**Replat – Southport West Replat Nine – Southport
West Partners, LLC**

**CITY OF LA VISTA
PLANNING DIVISION
RECOMMENDATION REPORT**

RE: Southport Parkway Replat Nine – Initial Review Letter
Preliminary and Final Plat
Lots 23-26 Southport West and Lot 1 Southport West Replat Four

RE: Southport Parkway Replat Nine – 2nd Review Letter
Preliminary and Final Plat
Lots 23-26 Southport West and Lot 1 Southport West Replat Four

PRELIMINARY PLAT
PRELIMINARY PLAT SUBMITTAL
SOUTHPORT WEST REPLAT NINE
PHASE 1
LA VISTA, NE

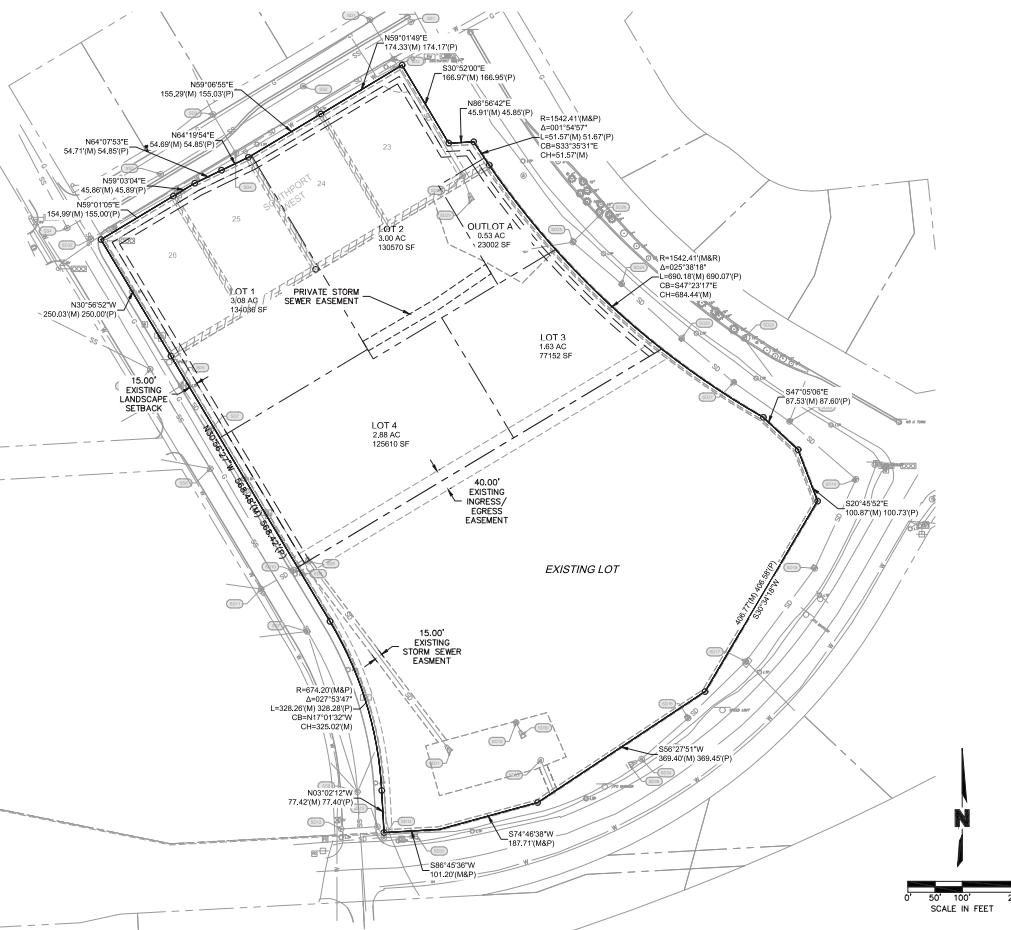
1. Please include phasing lines on the preliminary plat if the development will be constructed in phases, per Section 3.03.02 of La Vista's Subdivision Regulations.

2. Per Section 3.03.07, please include all existing utilities, with their sizes indicated, as well as flowlines, elevations of existing sanitary sewers, water mains and storm water drainage.

3. Per Section 3.03.10, please include all easements, including any cross-lot easements and any proposed easements to be vacated. Although a Cross-access easement exists on the original plat for Southport West, it should be reiterated on this plat, along with a cross-parking easement.

8. Per Section 3.05.09, please provide the square footage of the proposed lots.

11. The proposed access along Southport Parkway is currently platted as a right out- only, however paving plans show what appears to be a right in, right out access. Please adjust the access constraints in plat accordingly.

Response: Phasing map has been included.

Response: Existing utility information has been provided as requested.

Response: Cross access information has been updated and provided on the preliminary and final plat.

Response: Square Footage has been added to both preliminary and final plat.

Response: Plat has been updated to include this as a right-in/right-out access.

PHASING MAP

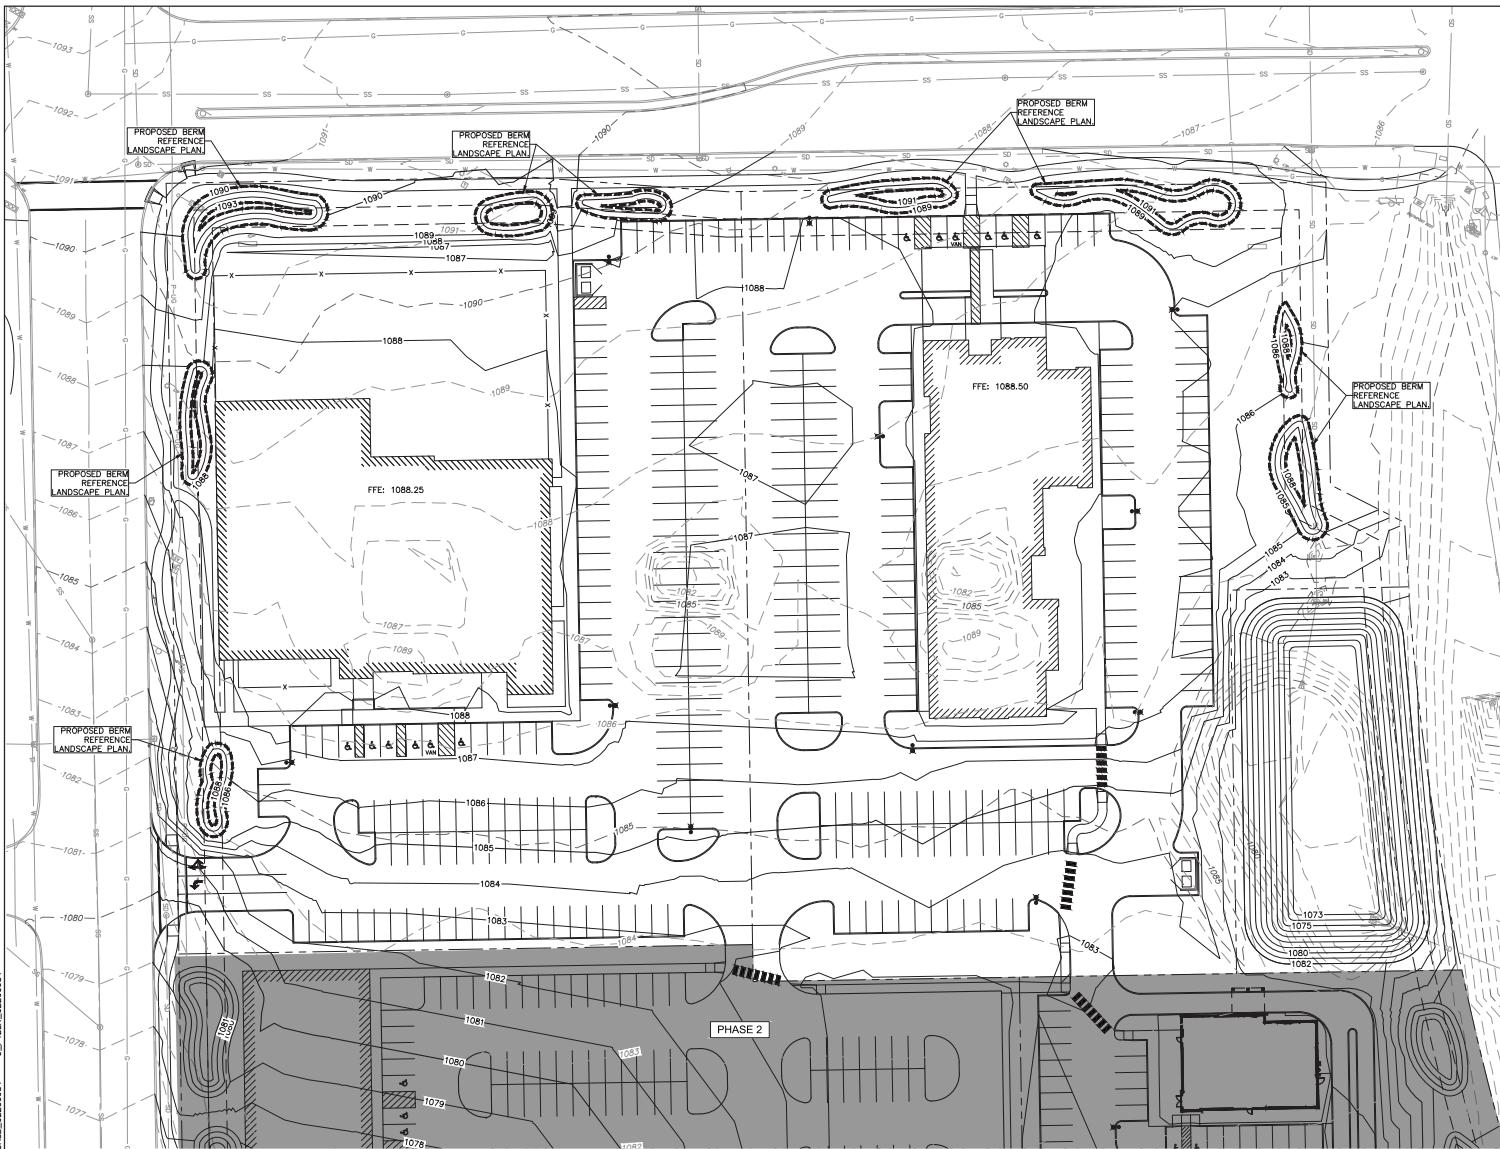
14. In review of the Overall Site Exhibit, it does not appear that the conceptual level paving layout accounts for internal circulation between the proposed Phases 1 and 2 along the phase line at the east end of the project. The applicant should complete the conceptual paving layout to a level that accounts for the alley width, return radii, and extents of paving required for orderly internal circulation between the two phases.

Response: This map has been revised.

FINAL PLAT

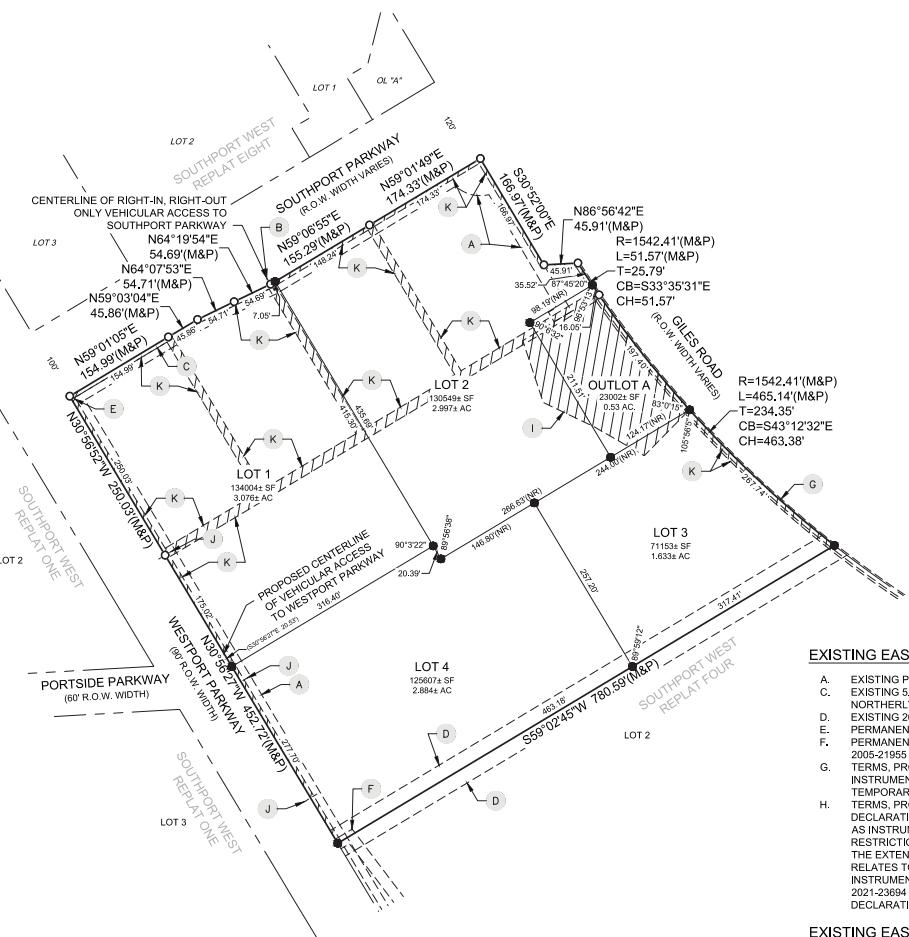
2. Per Section 3.03.10, the cross-access easement should be reiterated on this plat. A cross-parking easement also needs to be added to the Final Plat.

6. Note 4 on the Final Plat states that "no direct access shall be permitted onto Giles Road from Lots 1 and 2 or Outlot A". Lot 1 does not have frontage on Giles Road. Please revise this note to state that "no direct access shall be permitted onto Giles Road from Lots 1 and 3 or Outlot A"

Response: Per discussions, a note will be added to the Preliminary and Final Plat regarding cross parking for the lots.

Response: Note has been revised accordingly based on the relabeling of lots which occurred with the previous iteration.
